**SPECIAL MEETING OF CITY COUNCIL
FEBRUARY 2, 2018 – 3:00 PM
MUNICIPAL COURTROOM
GEORGETOWN, SOUTH CAROLINA**

Storm Drainage Improvements - Phase I

Change Order No. 2

Change Order No. 3

Arrow points to location of sewer line

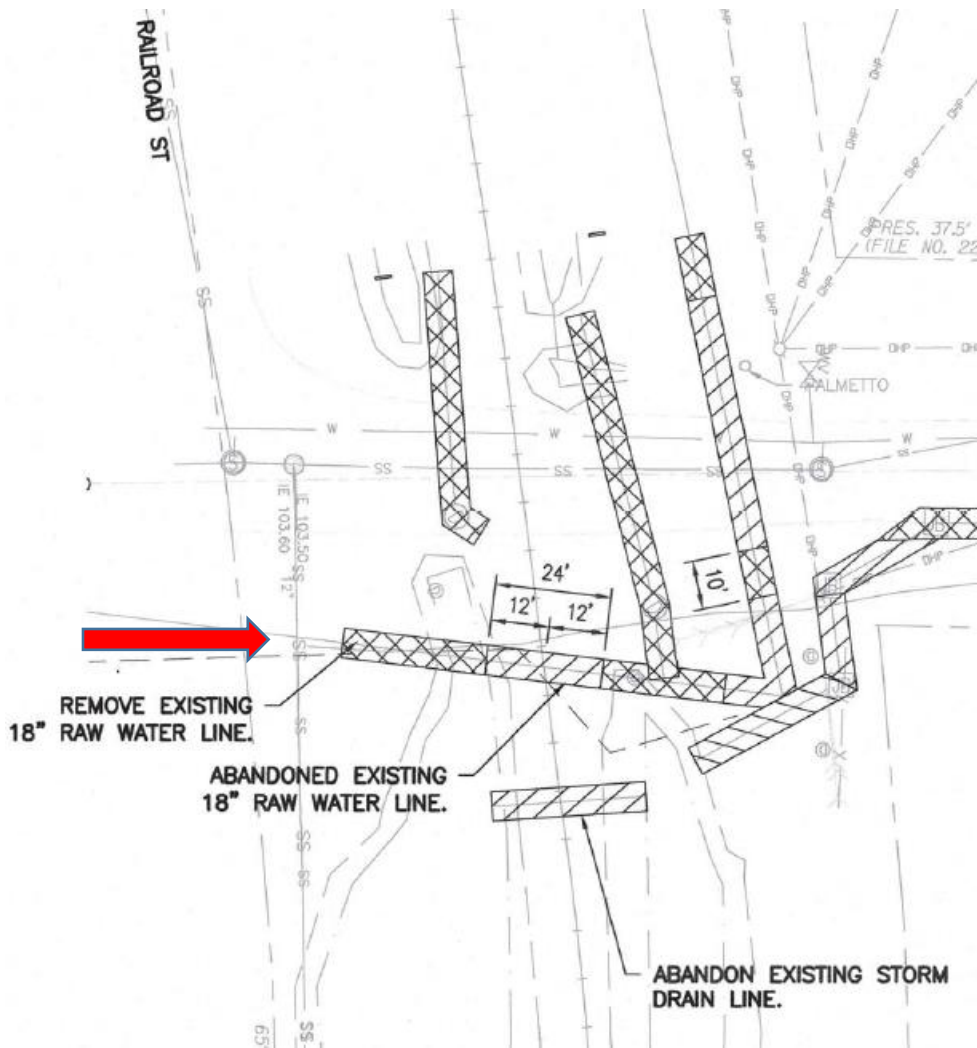
1. Demo & reinstall approx 30 LF of existing sewer line.
2. Sewer bypass on N. Congdon St.

Revised Drawings.

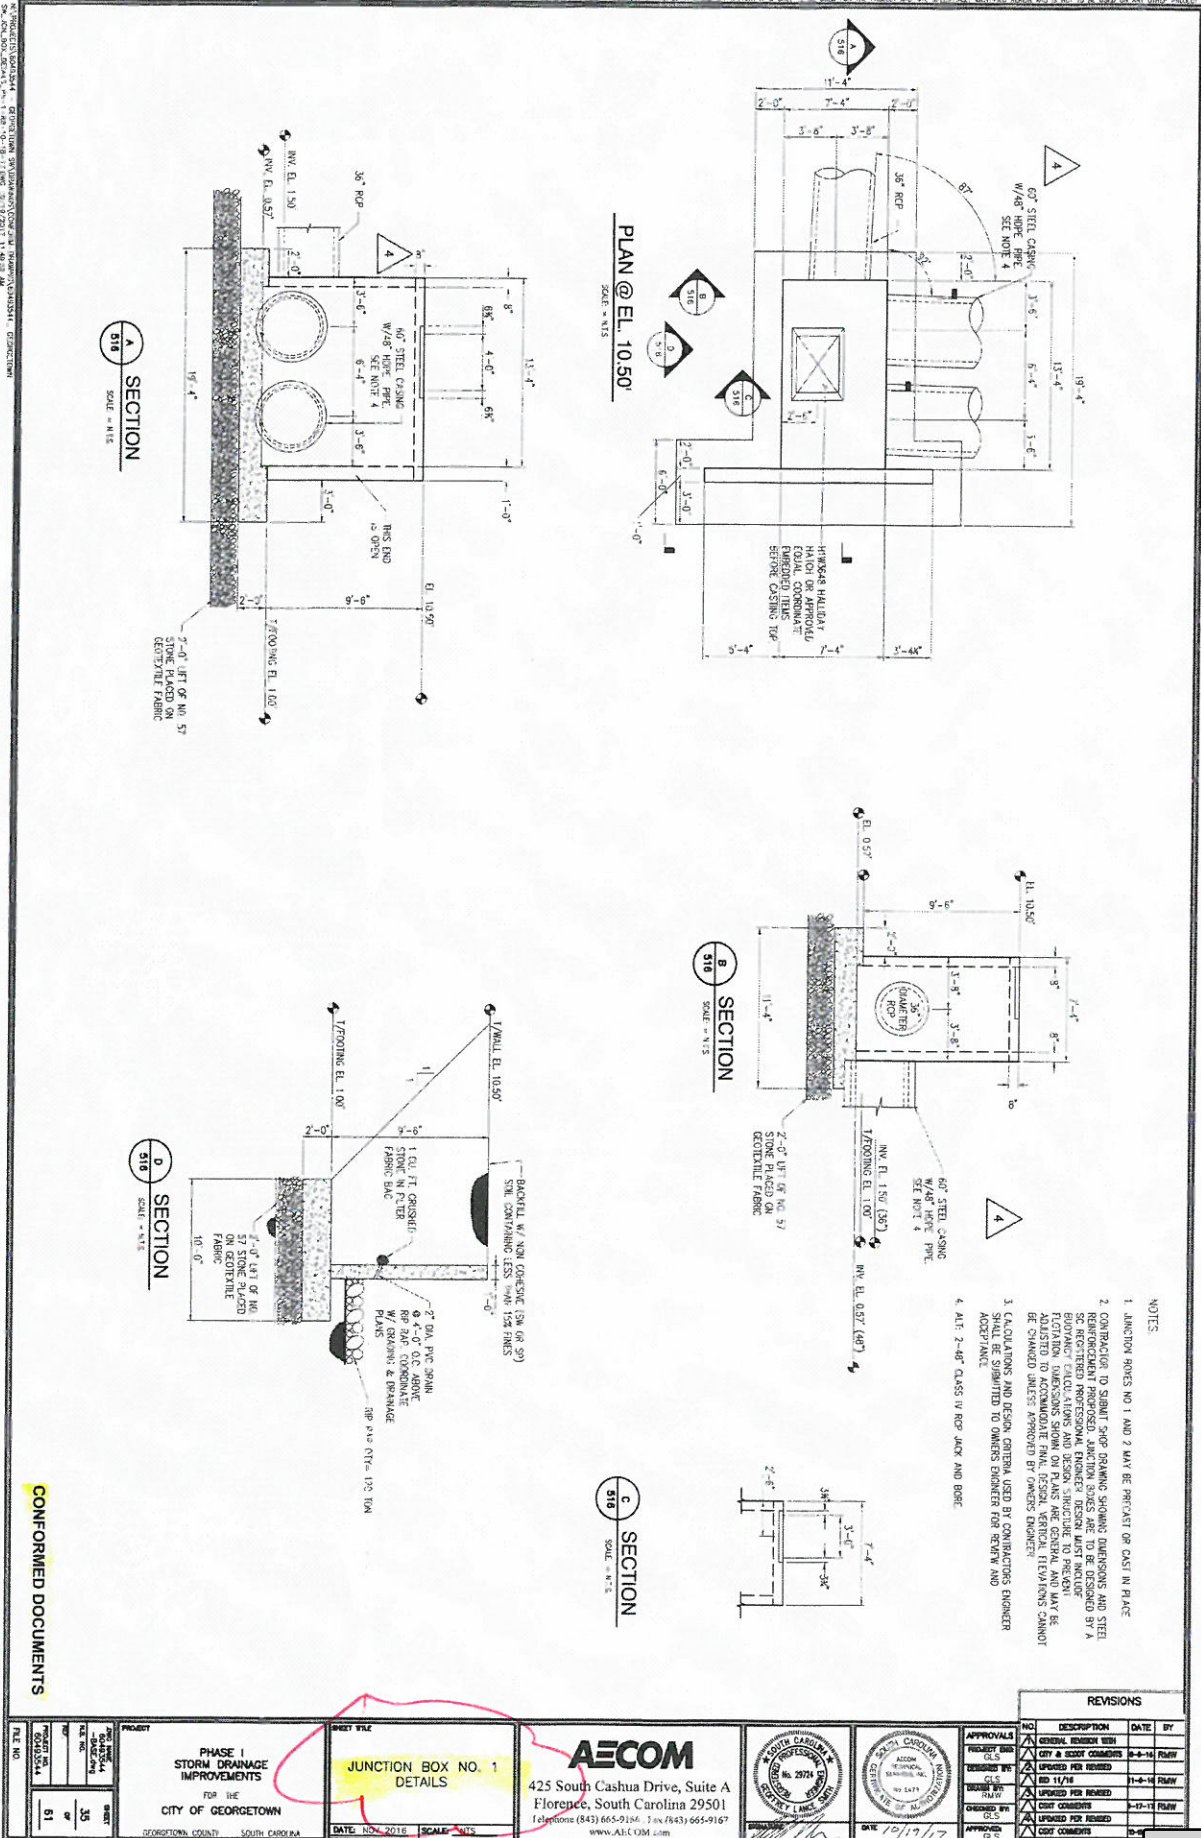
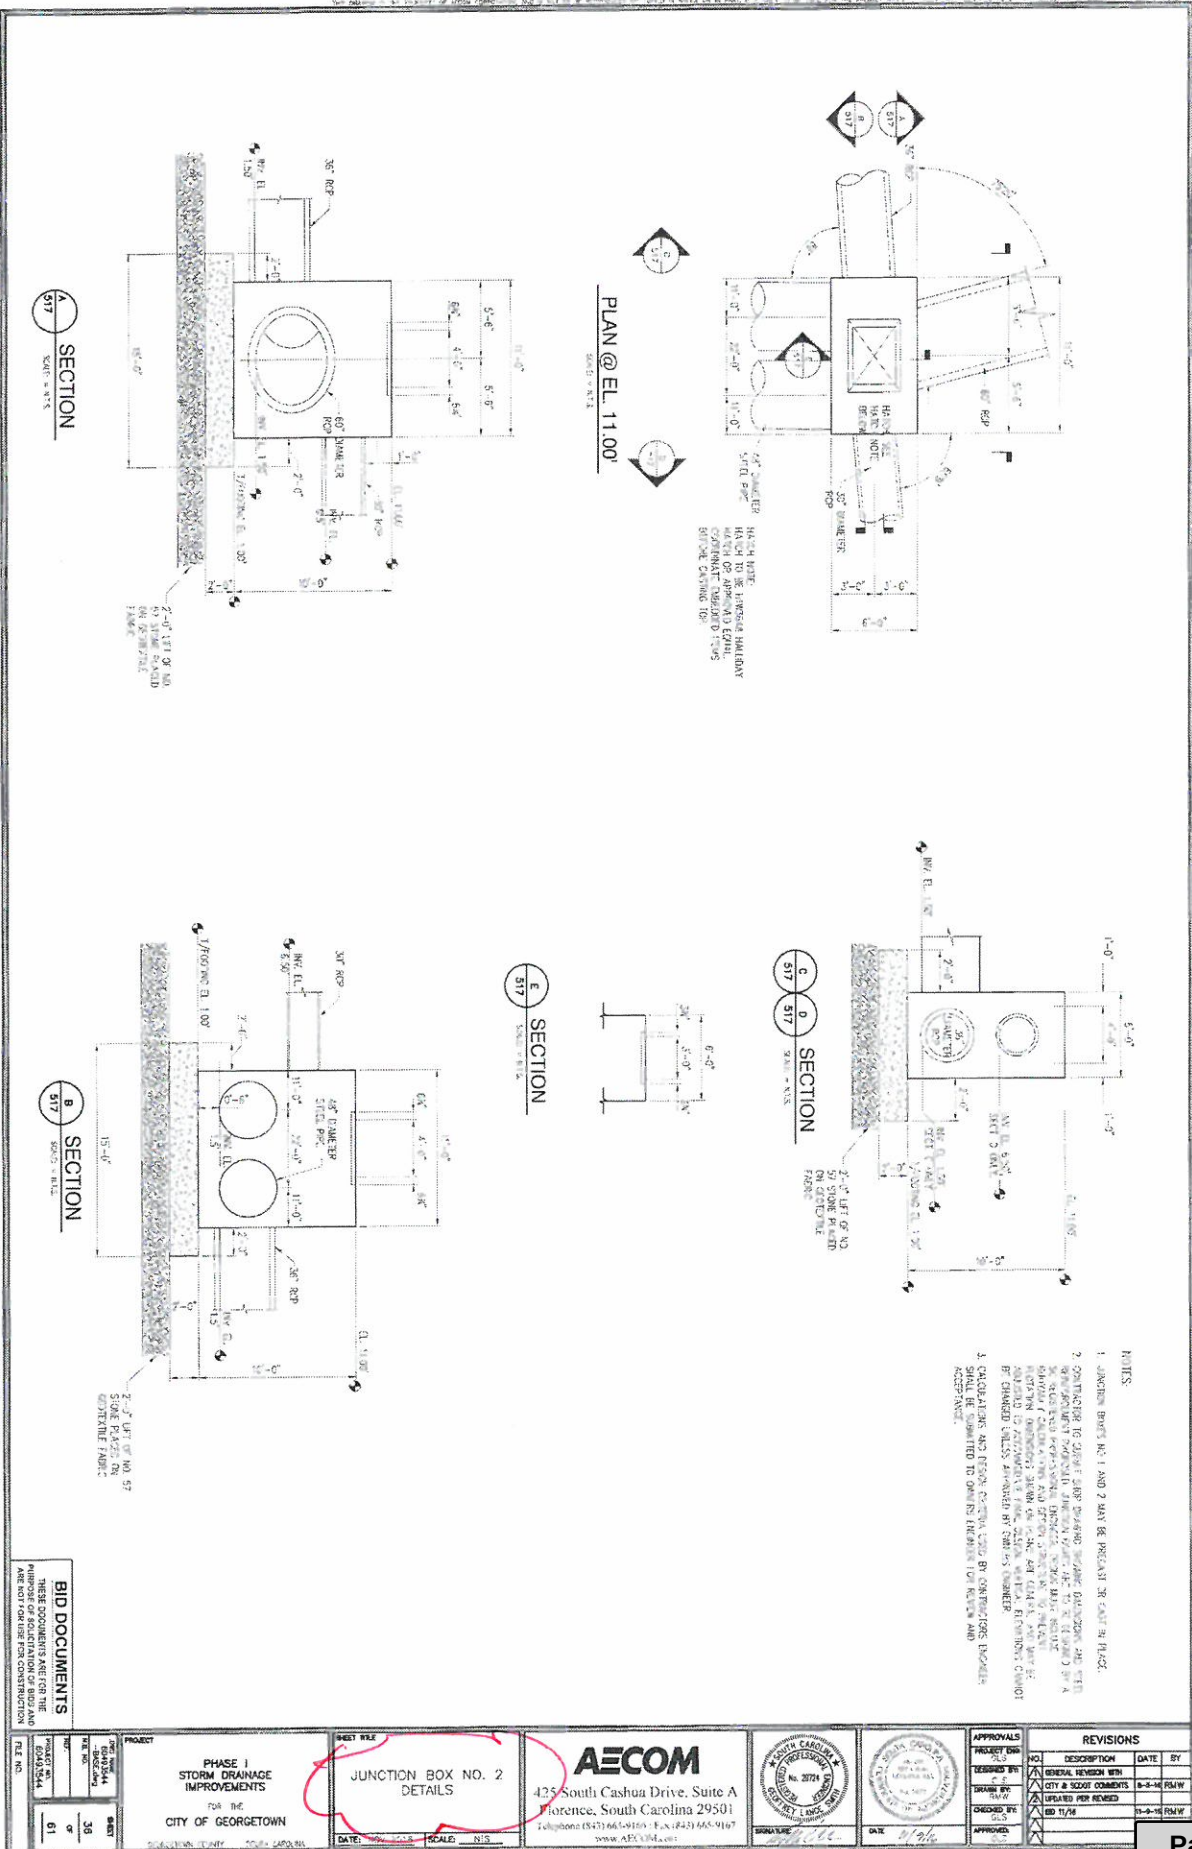
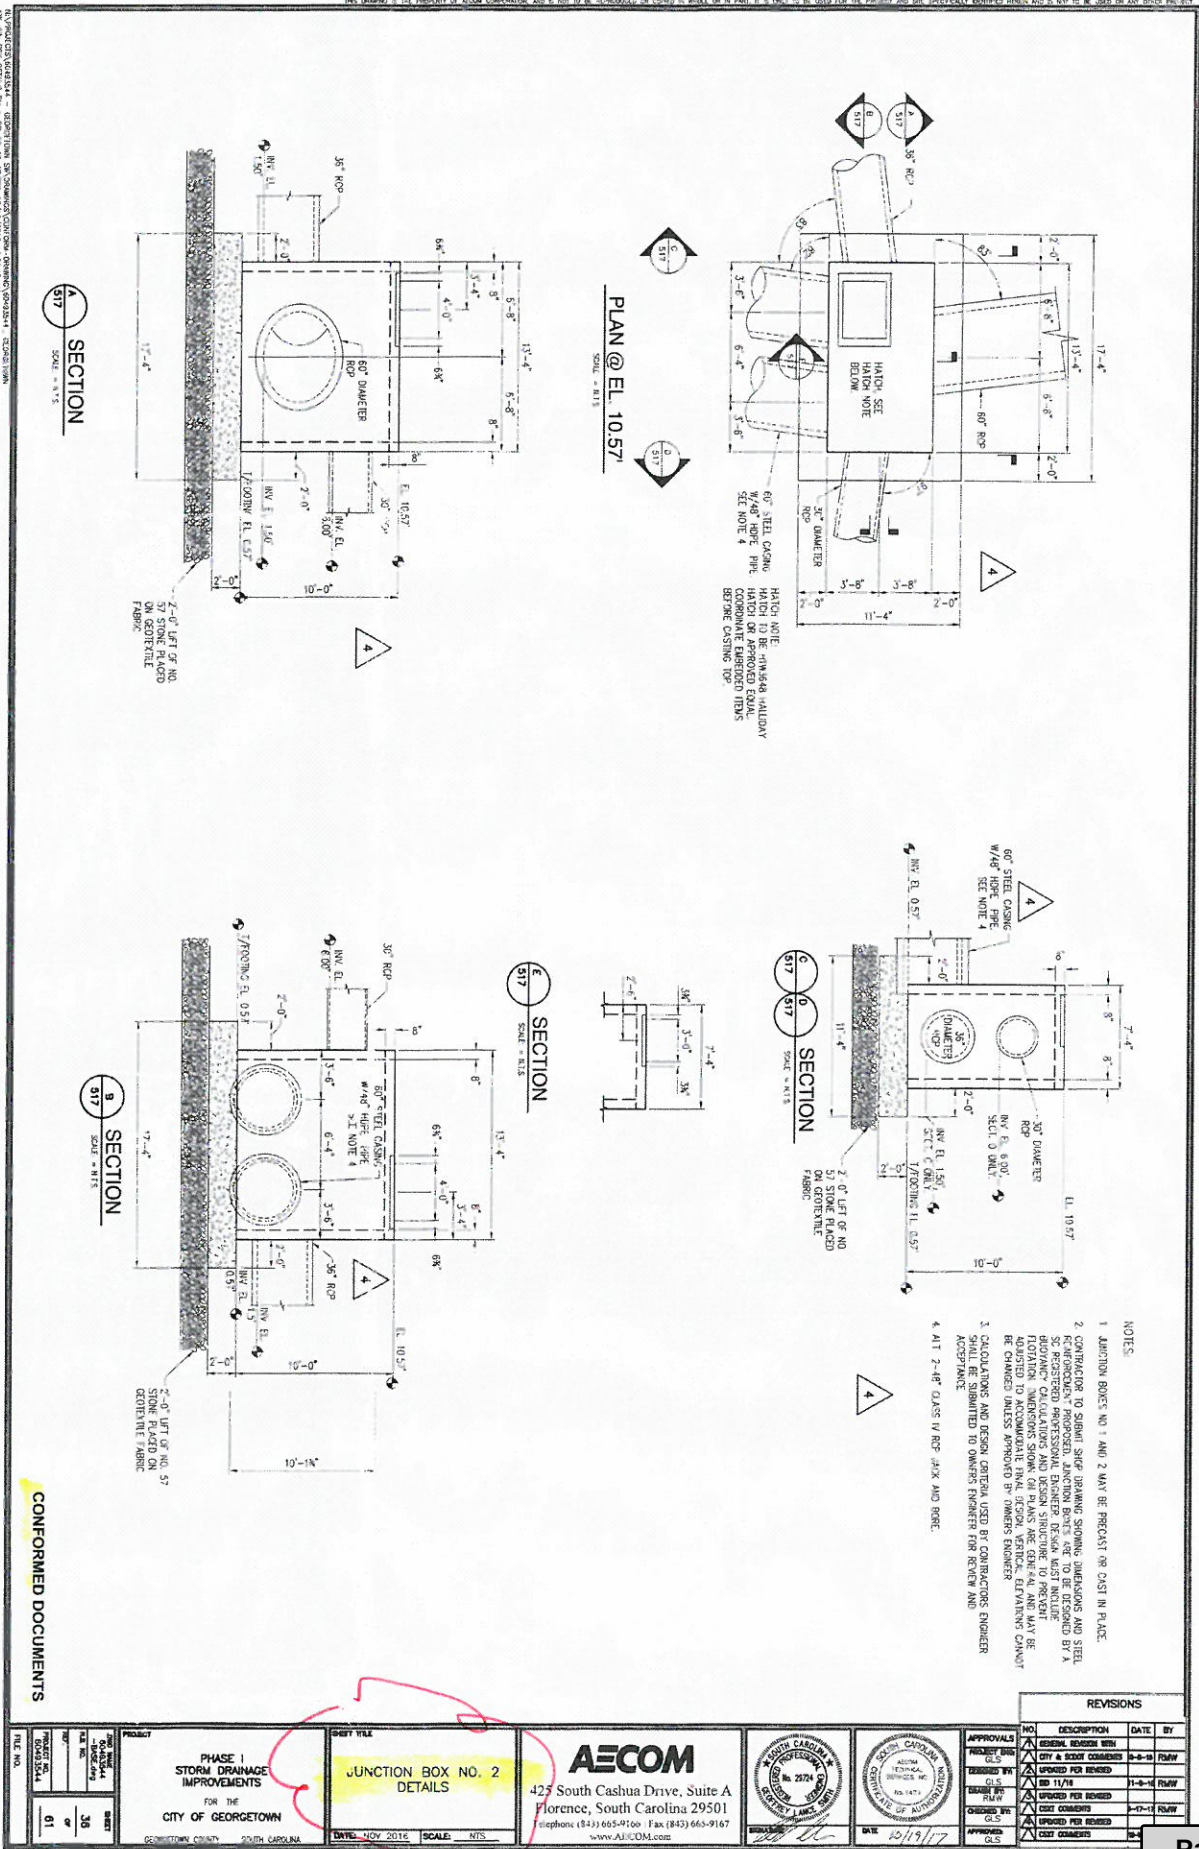
1. Junction Boxes 1 & 2 size change due to CSX requirements.
2. Addition of 24 foot to Jack & Bore 60" Steel Pipe Casing.
3. Additional 24 foot of 48" HDPE in casing installed

Photo No. 2
Description: Right Elevation. Arrow points to roof soffit which lacks perforated panel at the bottom.

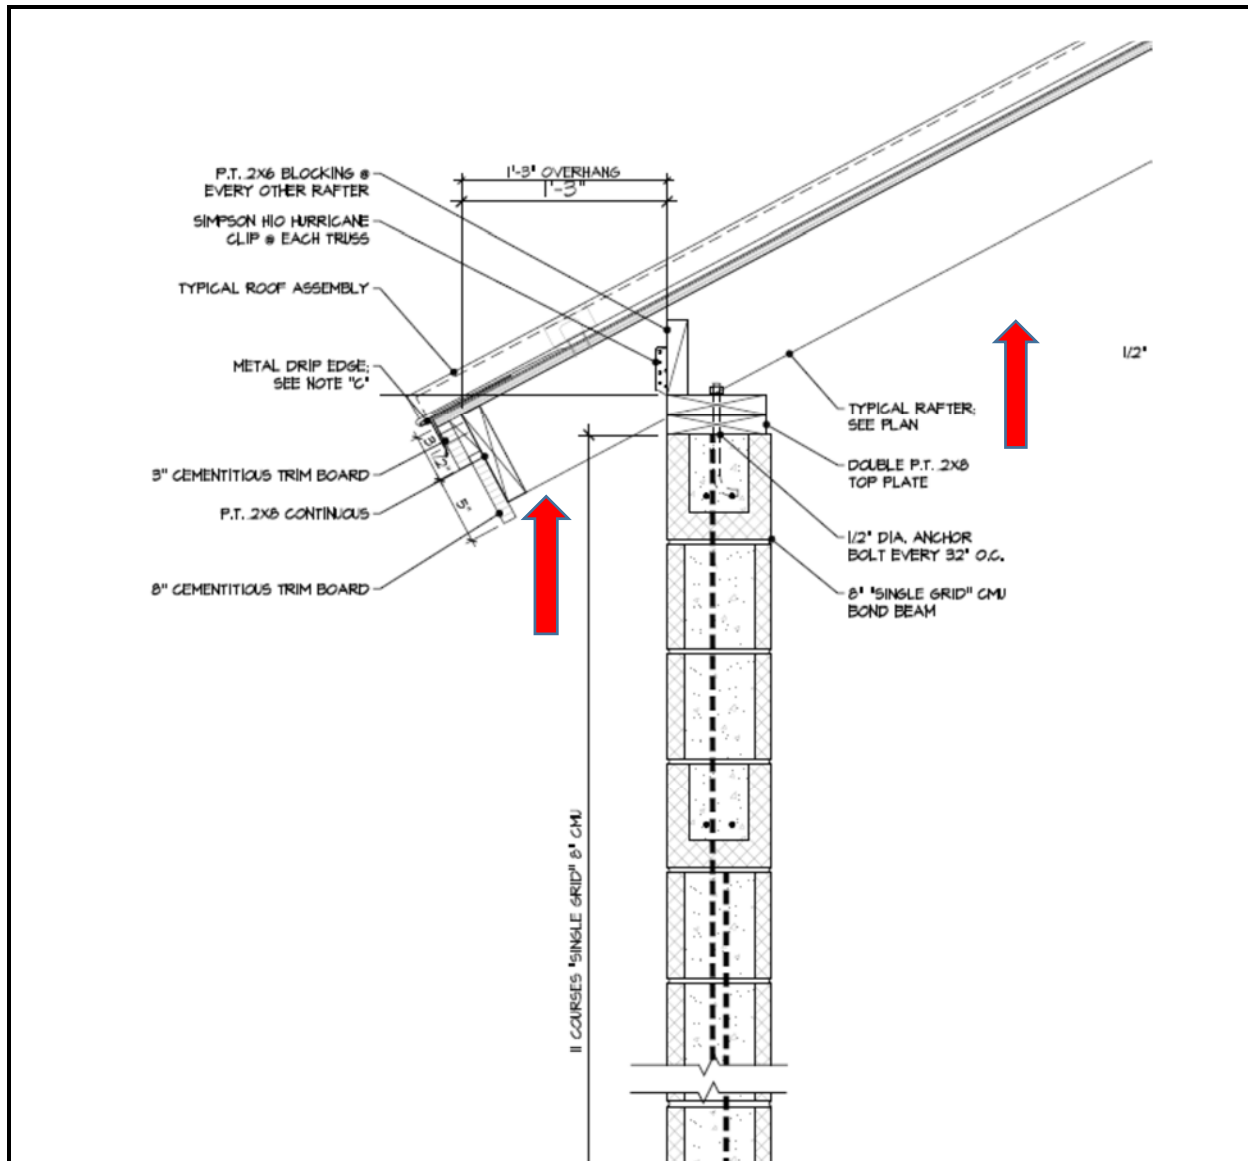
Description: View of men's room interior ceiling. Arrow indicates exposed rough lumber

Description: View of women's room interior ceiling. Arrows indicate exposed rough lumber and openings in the bottom of roof rafters (exterior soffit)

Description: View of architectural drawing: Wall section thru bathroom. Arrows point to lack of soffit material in the exterior and ceiling in the interior.

1. Furnish and install Hardi panels, trim ceiling, including miscellaneous framing, painting with two coats of recommended paint. Installation of perforated soffit around the building as per estimate submitted. \$11,350.00
2. Installation of recommended Radiant Heaters, including wiring, materials and labor
 Install Hand dryers (quantity 2) with all labor, material and relocate existing wire to above rafters to accommodate ceiling, Hardi boards and trims \$5480.00
